APPLICATION NO.	FILING DATE	FIRST NAMED INVENTOR	ATTORNEY DOCKET NO.	CONFIRMATION NO.
10/643,934	08/20/2003	Woo-Shik Lee	6192.0307.US	5383

Office Action Summary

10/643,934

Fig. 6

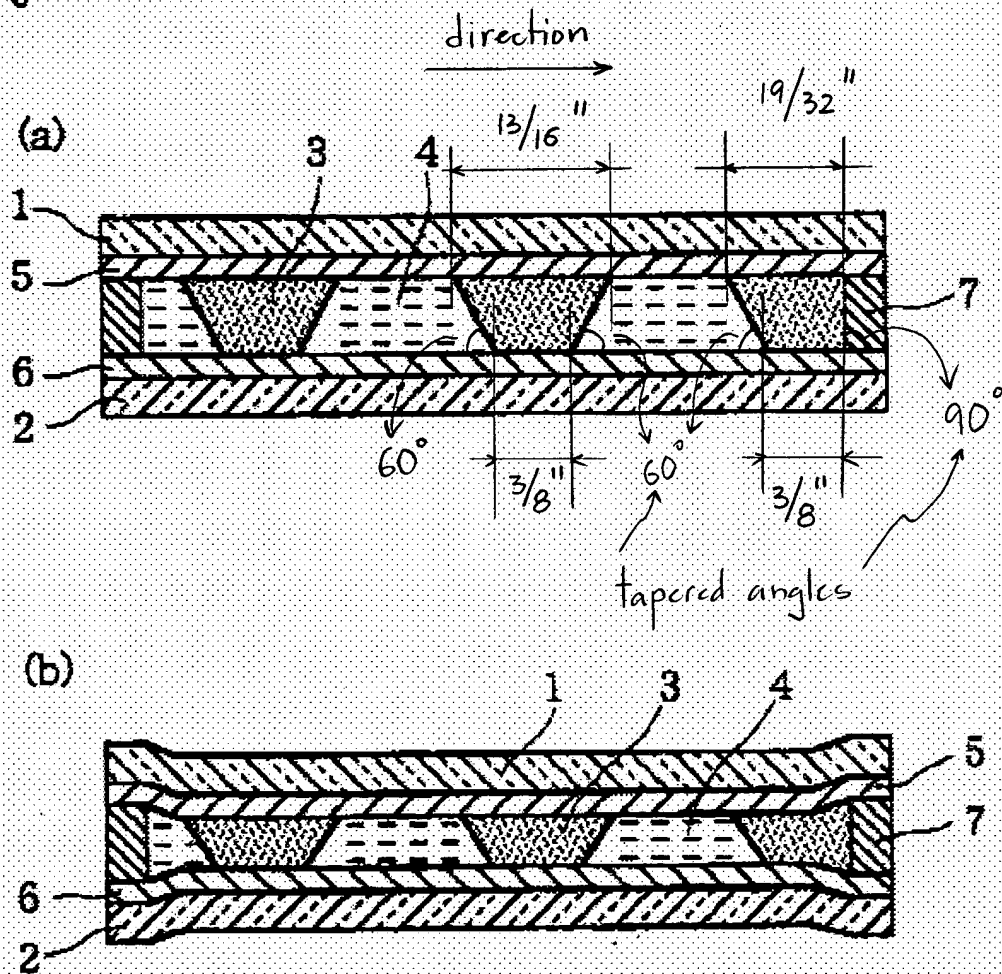
Re claims 1 and 14, as shown in Fig. 6(a) below, Nishiyama discloses a liquid crystal display apparatus comprising:

- a first substrate 2 including a display region for displaying an image;

- a second substrate 1 facing the first substrate 2;

- a fence 7 disposed between the first substrate and the second substrate, the fence surrounding the display region to form a space defined by the first and second substrates and the fence;

- a liquid crystal layer 4 disposed in the space; and

- a plurality of spacers 3 disposed in the space, the spacers maintaining the distance between the first and second substrates, the spacers having a gradually increasing compression ratio in a direction from a center of the display region to an edge of the display region,

wherein, re claims 4 and 17, the spacers 3 are tapered, a side face of the spacer and the first substrate forming a tapered angle, the tapered angle of the spacers gradually increasing in the direction, a product of an upper diameter and a lower diameter of the spacers decreasing in the direction;

wherein, re claims 5 and 18, a difference of the tapered angle of the spacer disposed at the edge, which is 90 degrees and the tapered angle of the spacer disposed at the center, which is about 60 degrees, is no more than about 40 degrees; and

wherein, re claims 6 and 19, the spacers are tapered, such that a tapered angle is constant, a side face of the spacer and the second substrate 1 forming the tapered angle, a diameter of the spacers decreasing in said direction (Fig. 6(a)).

Re claims 7, 8, 20 and 21, it is inherent that a polymer linking density of the spacers and Young's modulus of the spacers decrease in the direction due to reduction of cross-section areas of the spacers in the direction as shown in Fig. 6(a).

The most relevant reference, USPN 6,507,385 B1 of Nishiyama et al. (Nishiyama), fails to disclose the above condition. As shown in Fig. 6(a), the Nishiyama's reference discloses:

$A_{\text{center}} = .2217$, where diameter of cross-section at center is $17/32$ inch

$A_{\text{edge}} = .1726$, where diameter of cross-section at edge is $15/32$ inch

$$A_{center}/A_{edge} = 1.2845$$

$$1 + 0.1A_{center} = 1.0222.$$

Thus, Nishiyama fails to satisfy $A_{center}/A_{edge} < 1 + 0.1A_{center}$.
